**Planned Unit Development Amendment – Lots 1-3
& Outlot A Southport West Replat Eight –
Southport Parkway, LLC**

**CITY OF LA VISTA
PLANNING DIVISION
RECOMMENDATION REPORT**

CASE NUMBERS: PPUD23-0001;

RE: Planned Unit Development Amendment – Initial Review Letter
Lots 1, 2, 3, and Outlot A Southport West Replat 8

VICINITY MAP

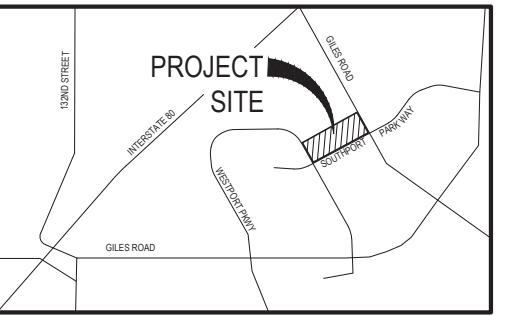
1. As per Section 5.15.5.06 a vicinity maps needs to be included in the PUD Site Plan that meets the requirements of the aforementioned section of the Zoning Ordinance. Although a vicinity map has been provided on the latest submittal, the location it depicts is wrong.

Response: The Vicinity Map has been revised as noted.

PLANNED UNIT DEVELOPMENT
SITE PLAN

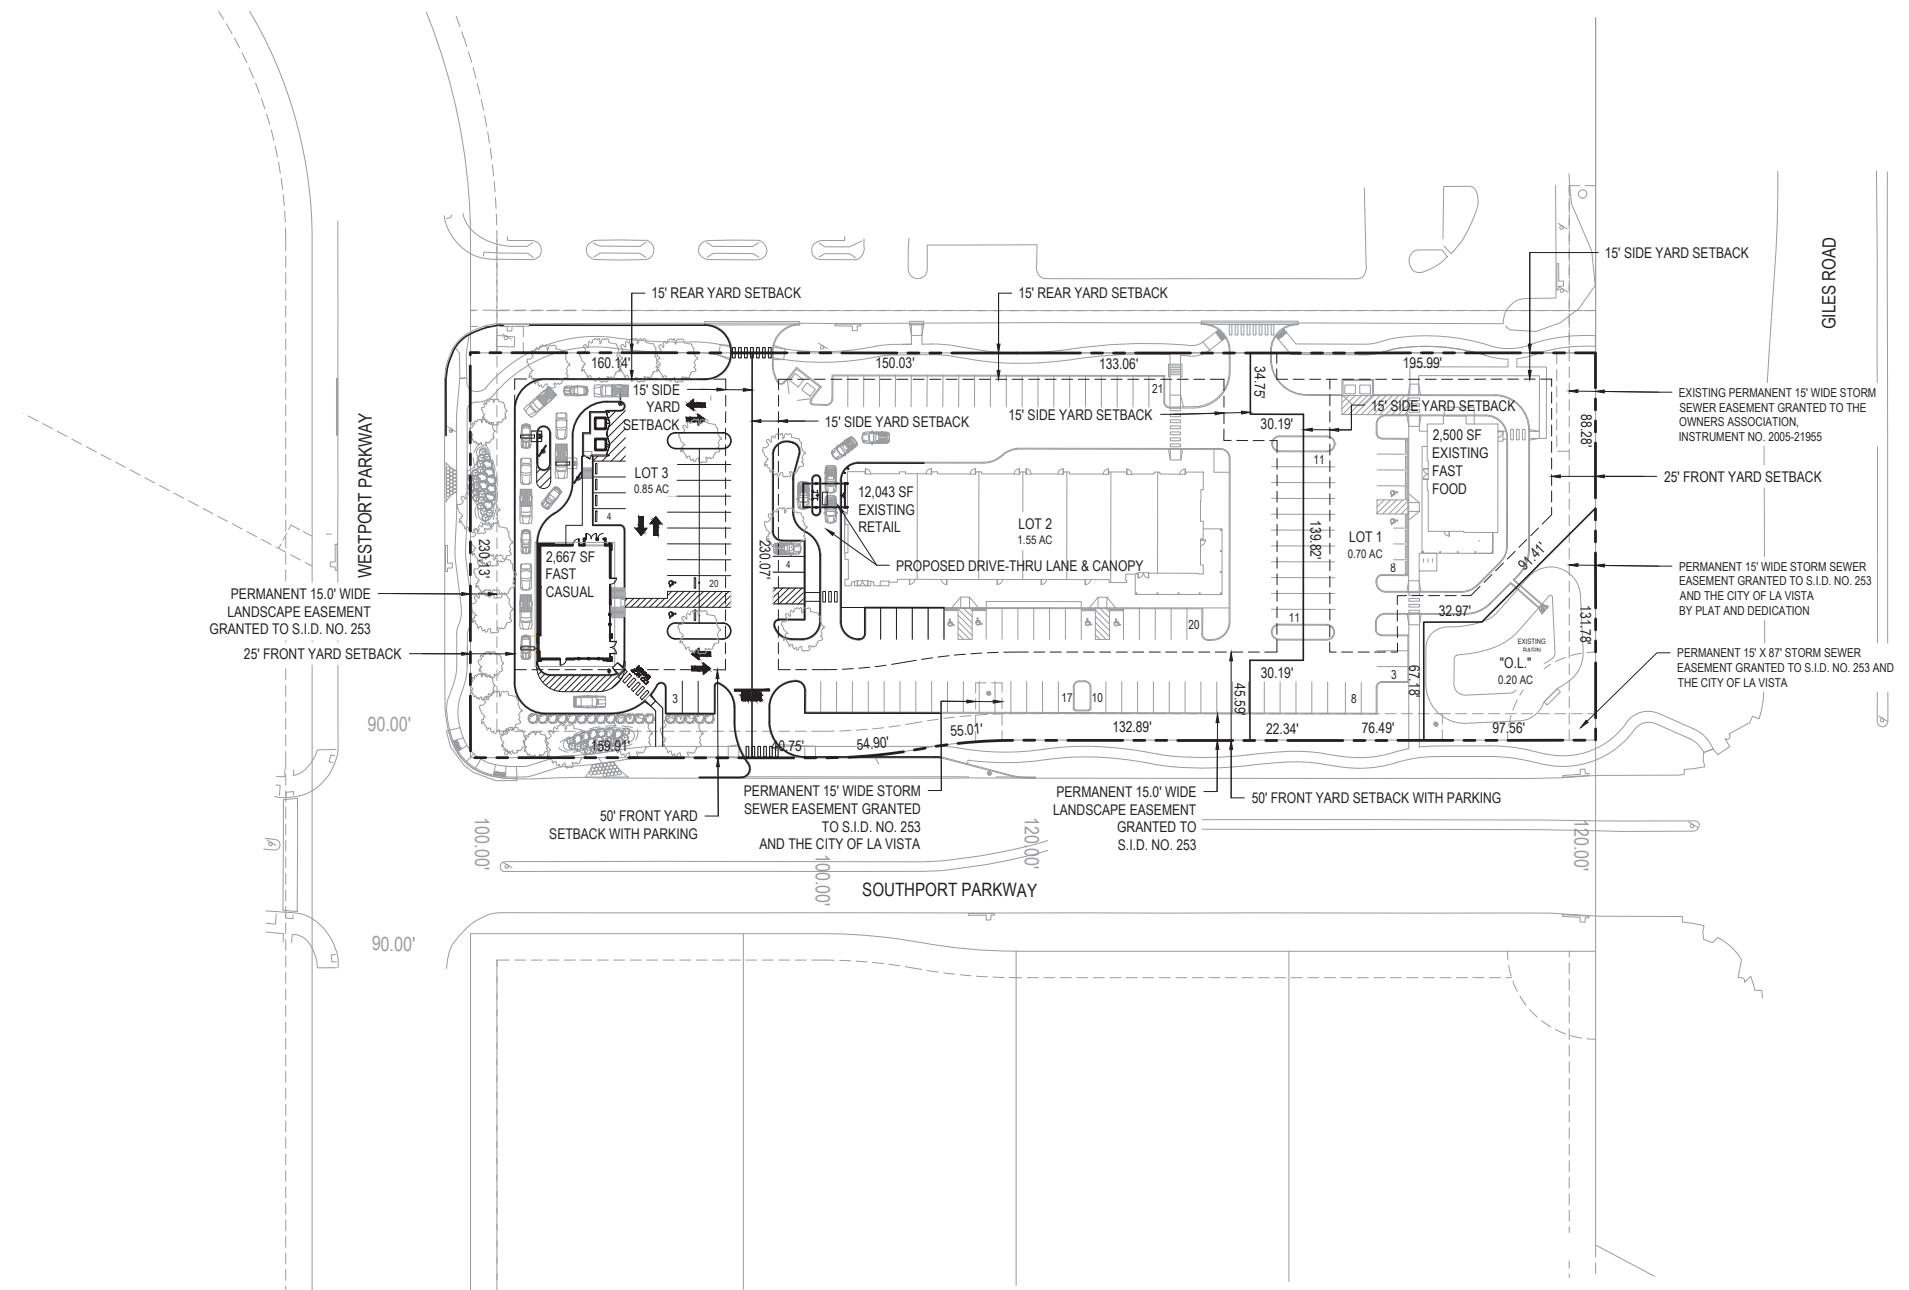
7. Widths of existing right-of-ways need to be displayed.

2. Please show how an internal pedestrian circulation is made between Lot 3 and 3.

1. As per Section 5.15.05.06 a vicinity map needs to be included in the PUD Site Plan that meets the requirements of the aforementioned section of the Zoning Ordinance. Although a vicinity map has been provided on the latest submittal, the location it depicts is wrong.

Response: These dimensions have been added to the PUD Site Plan.

Response: The internal connection has been added to the PUD Site Plan.
